# Presentation

<b>Agenda Item #</b>	1
<b>Meeting Date</b>	October 22, 2007
<b>Prepared By</b>	Suzanne Ludlow, Community and Government Liaison
<b>Approved By</b>	Barbara B. Matthews, City Manager

<b>Discussion Item</b>	Presentation of Alternative Transit Designs for the Takoma Metro station
<b>Background</b>	<p>As part of its continuing work to protect transit access to the Takoma Metro station in light of the proposed EYA development project, the City of Takoma Park retained Nelson\Nygaard Consulting Associates of New York City for planning assistance. The firm was asked to redesign the station's transit facilities in a way that accomplished the goals of providing 12 bus bays and safe access for pedestrians, disabled persons, bicyclists and other transit patrons while allowing for room for development on the site. The consultants also considered other goals for the site, including having a Village Green, protecting adjacent residential properties, and providing 150 short-term parking spaces on the site. Three main conceptual plans were drawn.</p> <p>Option A, and its higher-density variant, A-1, met most of the requirements of Ride On transit staff and Nelson\Nygaard staff was a

**Takoma Metro Station**  
Nelson\Nygaard, 2007

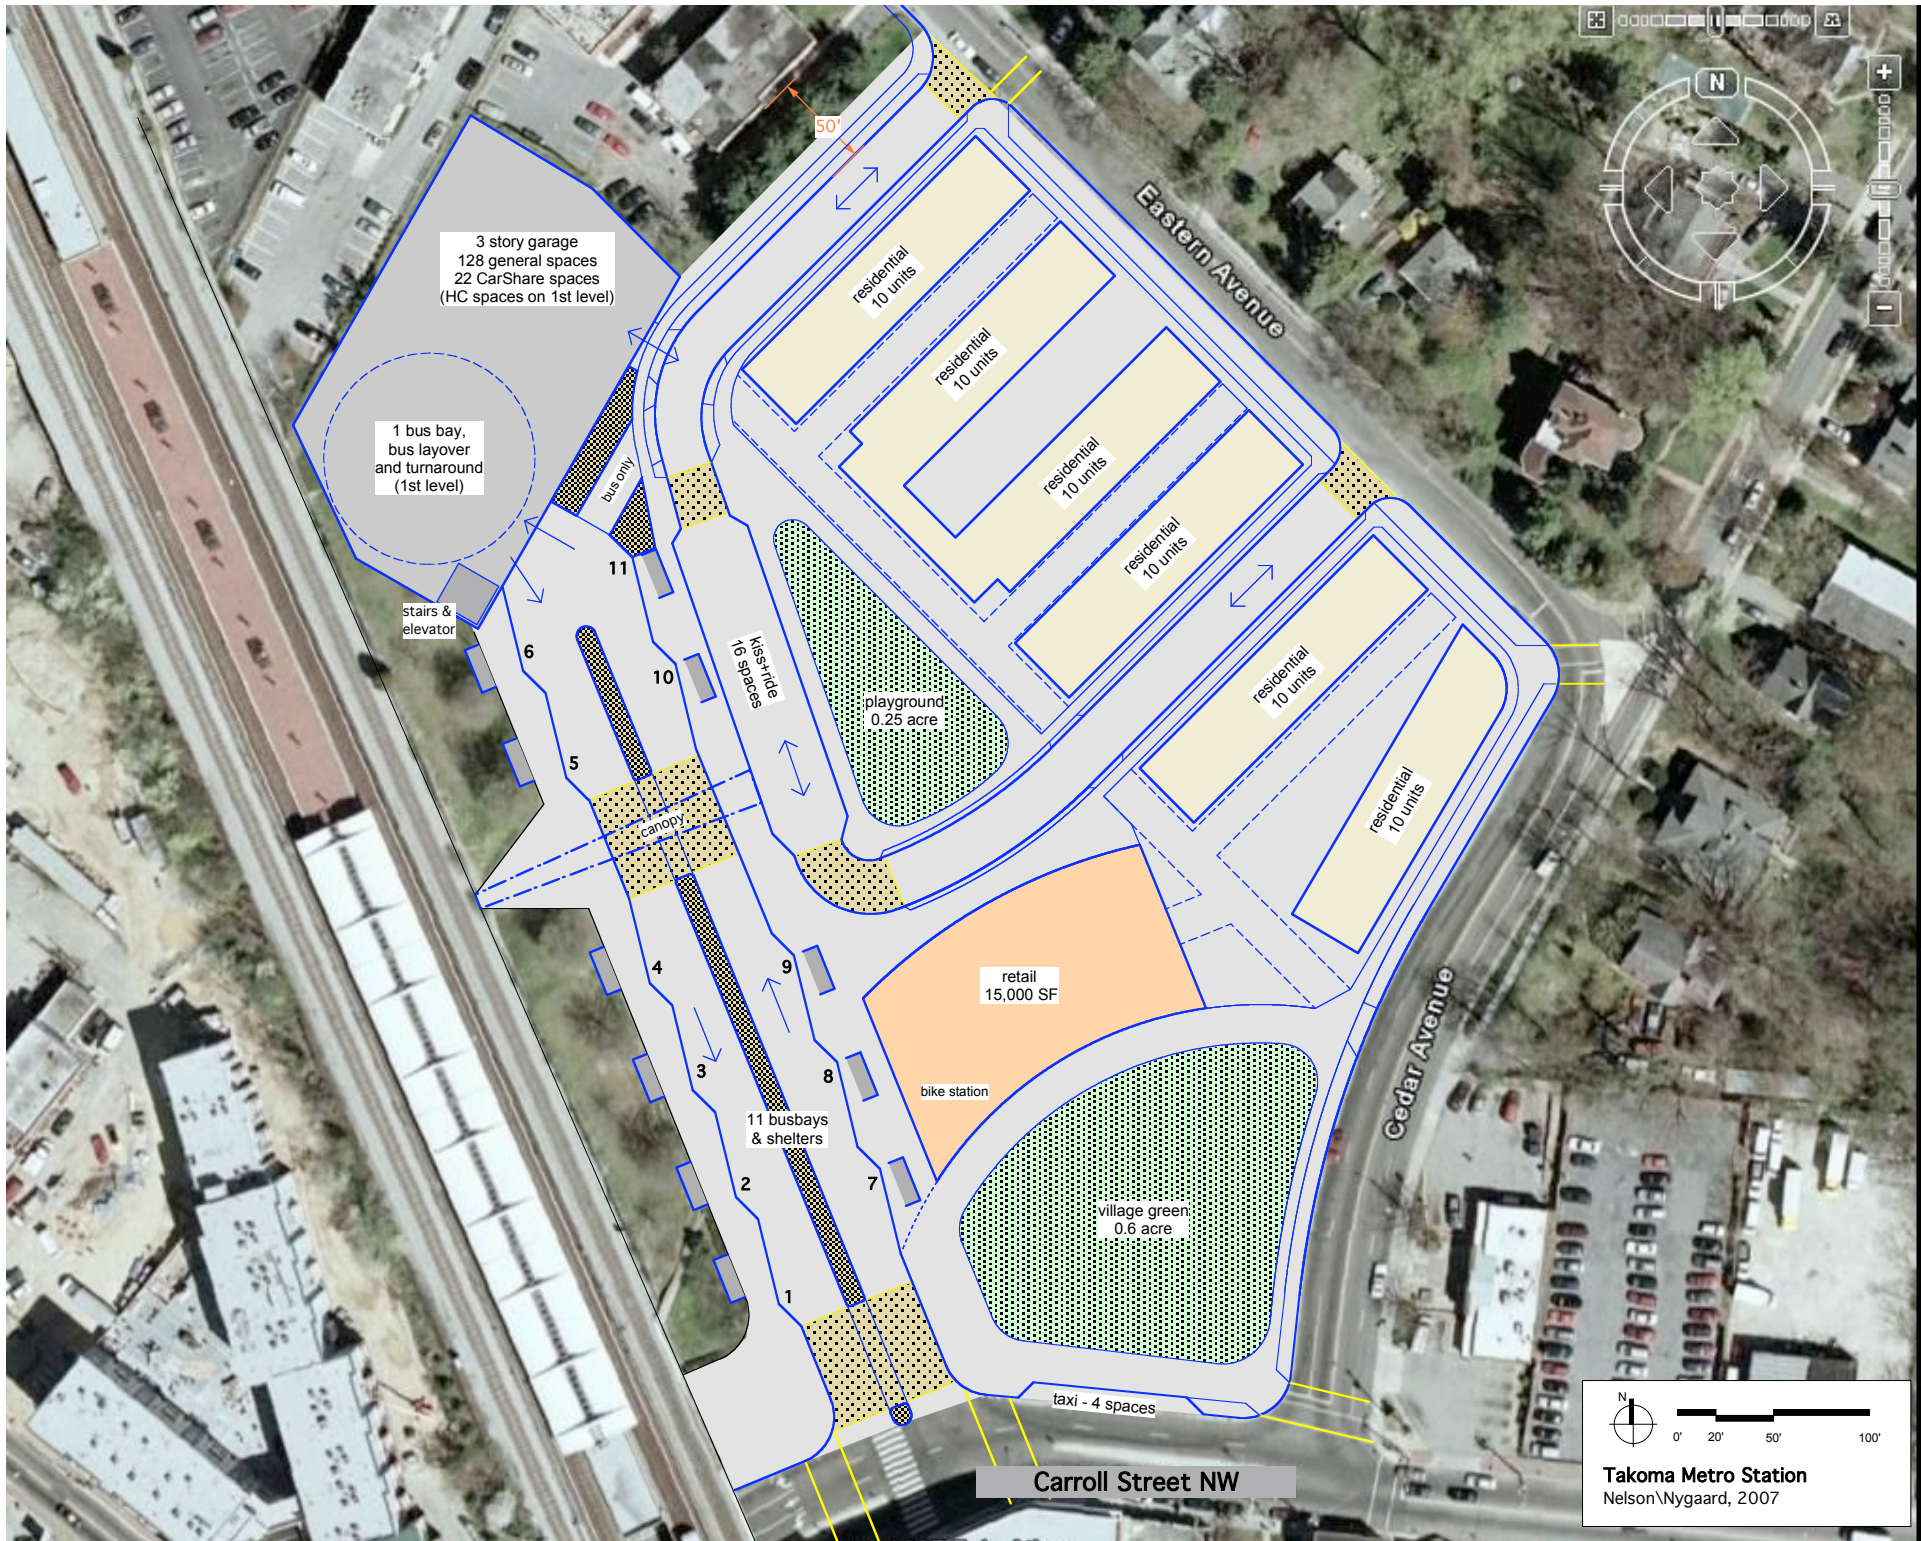
Issue	EYA Plan, revised 08/07	Option A
Main Station Entrance	<ul style="list-style-type: none"> <li>• Reduces plaza at entrance by 56 feet from existing</li> <li>• Bus bay and shelter right at entrance constrains crosswalk and reduces visibility</li> <li>• Reduction of plaza length, combined with grade change on Carroll St near entrance makes area more difficult to enter for people for whom slopes and stairs are difficult</li> <li>• Short length of plaza means not enough room for a Carroll St crosswalk on western side of bus drive; pedestrians must cross Carroll east of bus lanes, then cross the wide bus lanes</li> <li>• Bus lane crossing is 70 feet wide, with no median in the crosswalk as a refuge</li> <li>• The breadth of the crosswalk is only 15 feet due to the location of the first bus bay</li> <li>• A traffic signal at the bus entrance is required; the signal should be able to be triggered by pedestrians</li> </ul>	<ul style="list-style-type: none"> <li>• Reduces plaza by 26 feet from existing</li> <li>• No bus bay or shelter is at entrance</li> <li>• The larger plaza than the EYA plan allows for less grade difference from Carroll St</li> <li>• The larger plaza than the EYA plan allows for a crossing of Carroll St at the entrance, with no need to also cross the bus lanes</li> <li>• The 62 foot wide crosswalk of the bus lanes includes a 10 foot wide median as a refuge; the breadth of the crosswalk is 70 feet, giving prominence to the pedestrian crossing</li> <li>• The crosswalk is well away from the first bus bay for enhanced safety and visibility</li> <li>• A traffic signal at the bus entrance is required; the signal should be able to be triggered by pedestrians</li> </ul>

Pedestrian entrance from NW corner of property at Eastern Ave	<ul style="list-style-type: none"> <li>• 8 foot wide sidewalk provided, obstructed by tree boxes; 10 foot wide unobstructed path is standard for shared bike/ped path</li> </ul>	<ul style="list-style-type: none"> <li>• Room for at least a 10 foot wide unobstructed path, meeting standards even though bikes will be less likely to use this route than with the EYA</li> </ul>

Issue	EYA Plan, revised 08/07	Option A
(cont'd) Pedestrian entrance from NW corner of property at Eastern Ave	<ul style="list-style-type: none"> <li>• Sidewalk is also narrowed by bike lockers and bus shelters</li> <li>• The reduced width of the slope down from the tracks, turns the slope more into a tall retaining wall; peds will feel squeezed between the wall and the bus shelters etc. making the walk feel uncomfortable</li> <li>• Good aspect: only one vehicular crossing to entrances</li> </ul>	<p>plan</p> <ul style="list-style-type: none"> <li>• Obstructing bike lockers not needed along path due to Bike Station</li> <li>• Bus shelters would be tucked into slope allowing a clear path</li> <li>• All crossings of vehicular paths will have broad crossings; raised crosswalks are recommended</li> <li>• The crossing of the bus lanes is approx 60 feet wide, including a 10 foot wide median; the breadth of the crossing averages 70 feet; no bus bays are in this area; it is recommended that the crosswalk be raised and that a canopy stretch from the elevator entrance to the Kiss and Ride drop off point</li> <li>• No reduction of width of landscaped slope between sidewalk and tracks so path feels comfortable</li> </ul>

Pedestrian entrance from Eastern & Cedar	<ul style="list-style-type: none"> <li>• 10 foot wide shared bike/ped path</li> <li>• To get to elevator, must go around bus/car traffic circle; path does not follow desire lines to entrance</li> <li>• View of either entrance is impeded until very close</li> </ul>	<ul style="list-style-type: none"> <li>• 12 to 15 foot wide shared bike/ped path easily accommodated; allows for trees without obstructing flow</li> <li>• Once around the residential buildings near Eastern &amp; Cedar, path follows desire lines</li> <li>• View of entrances is possible from much greater distance than in EYA plan</li> </ul>

Issue	EYA Plan, revised 08/07	Option A
Pedestrian entrance from Cedar and Carroll	<ul style="list-style-type: none"> <li>• Path appears to be only 8 foot wide, although path is heavily used by peds and is to be shared by Kiss and Ride patrons, persons going to businesses, and persons using the Village Green; bike riders also are likely to come this way from the Met Branch Trail</li> </ul>	<ul style="list-style-type: none"> <li>• Allows for a broad pedestrian way to the Metro station, 20 feet or more wide, accommodating the mix of users and setting a tone of the area as welcoming to pedestrians and transit users</li> </ul>
Access by Disabled Patrons	<ul style="list-style-type: none"> <li>• Multiple locations of handicapped parking spaces, Kiss and Ride spaces and drop off locations create confusion and long distances for disabled passengers</li> <li>• Most convenient location to drop off disabled passengers is in the bus/car traffic circle at the end of the fence, but causes congestion and disruption of buses; unless use garage, all other paths have long distances and less safe ped crossings</li> <li>• Handicapped drop off in the garage has no clear view of the elevator entrance</li> <li>• Persons leaving station from either exit cannot see if or where someone might be waiting for them due to obstructed views and scattered Kiss and Ride locations; this is more unsettling for more vulnerable passengers</li> <li>• Reduced plaza length at</li> </ul>	<ul style="list-style-type: none"> <li>• Drop off area across from elevator has clear view to elevator, but must cross at main crossing of bus lanes; recommendation is for a raised crosswalk and a canopy to the elevator</li> <li>• Single Kiss and Ride pick up location, in a visible location, eliminates confusion for patron</li> <li>• Main entrance can be used by persons with mobility impairments but who are not in wheelchairs; a drop off location at this entrance could be considered on Carroll Street</li> </ul>

<b>Issue</b>	<b>EYA Plan, revised 08/07</b>	<b>Option A</b>
(cont'd) Access by Disabled Patrons	main entrance means more of a slope exists at the entrance making this entrance more difficult for persons who are mobility impaired but are not wheelchair users	
Bicycle access	<ul style="list-style-type: none"> <li>• Plan directs bicycle riders around the perimeter with 10 foot wide shared ped/bike paths, meeting minimum standard on Eastern and Cedar Avenues only</li> <li>• Bike access to the station is not welcomed; no bicycle circulation plan through the site is shown</li> <li>• Bike lockers are scattered through the sidewalk areas, obstructing the paths</li> </ul>	<ul style="list-style-type: none"> <li>• Plan welcomes bike riders around and through the site with wide shared paths</li> <li>• A Bike Station is prominently located opposite the main station entrance; much of the bike route to this location is on paths with less pedestrian traffic</li> <li>• Prominent location of Bike Station can add to numbers of patrons biking to the station and to the success of the retail area</li> </ul>

Vehicular Circulation On Site	<ul style="list-style-type: none"> <li>• Combined bus/car traffic circle is unwise at any transit station; its location near the most convenient point to access the elevator entrance will lead to cars dropping off passengers in the circle, while holding up buses and other cars; the proposed fence at the circle will only increase congestion as it limits drop off activity to only one car at a time</li> <li>• Plan has extremely confusing circulation system; even frequent users will need to circle through the site looking</li> </ul>	<ul style="list-style-type: none"> <li>• Plan separates bus traffic from car traffic, with the exception of a short, straight connection from the bus bays to Eastern Avenue for the small number of RideOn buses that need access to Eastern; the section has no drop off points</li> <li>• Plan has simple and logical traffic plan on site</li> <li>• Plan also separates public transit center traffic from vehicular access to the private residential properties</li> <li>• No interior parking spaces are to be found on site, so patrons will</li> </ul>

<b>Issue</b>	<b>EYA Plan, revised 08/07</b>	<b>Option A</b>
(cont'd) Vehicular Circulation On Site	<p>for parking and drop off locations at multiple sites</p> <ul style="list-style-type: none"> <li>• Dead-end alleys and streets, accessible to the public will cause cars to do U-turns and back up into the congested interior street</li> <li>• Buses will not be able to keep to schedule without active patrolling by Metro Police</li> <li>• A reduction in the number of public parking spaces in the lot/garage will cause people to look for the scattered parking spaces through the site, causing additional driving and confusion.</li> </ul>	<p>not drive around looking for them</p> <ul style="list-style-type: none"> <li>• The Kiss and Ride location and the garage are accessed from the same public road, minimizing confusion and congestion</li> </ul>
Bus Bays and Circulation	<ul style="list-style-type: none"> <li>• Plan has ten bus bays, with four interior layover spaces that could never be used as public bus bays when needed</li> <li>• Shared bus/car traffic circle is undesirable due to increased congestion, the likelihood of bus/car accidents, and delays in keeping to schedule</li> <li>• Location of bus bays at the two entrances blocks views of the entrances for patrons and causes patrons to have to walk a longer way around to get to the other side of the bus drives</li> </ul>	<ul style="list-style-type: none"> <li>• Plan accommodates 12 bus bays, as recommended by the Takoma Transportation Study; all bus bays are available for public use when needed</li> <li>• Bus traffic is kept separated from car traffic, except for a short, straight connection from the bus bays to Eastern Avenue for the small number of RideOn buses that need access to Eastern; the section has no drop off points</li> </ul>

Parking	<ul style="list-style-type: none"> <li>• The plan reduces parking in the public parking lot to approximately either 53 or 103 spaces (depending upon whether a surface lot or two level</li> </ul>	<ul style="list-style-type: none"> <li>• As strongly desired by the community, the plan keeps the approximately 150 parking spaces as exists today, in a three level garage</li> </ul>

Issue	EYA Plan, revised 08/07	Option A
(cont'd) Parking	<p>parking garage is chosen, with a drop off loop for disabled patrons), with an additional 42 spaces to be found scattered around the site; some are in front of the two-car garage townhouses</p> <ul style="list-style-type: none"> <li>• The confusion of finding parking on the site will be great, given the scattered parking space locations and the difficult-to-navigate street pattern on site</li> </ul>	<ul style="list-style-type: none"> <li>• No other parking spaces are on site, minimizing driving around looking for a place to park</li> <li>• Parking is to remain short term and can be more easily monitored by WMATA given its single location</li> </ul>
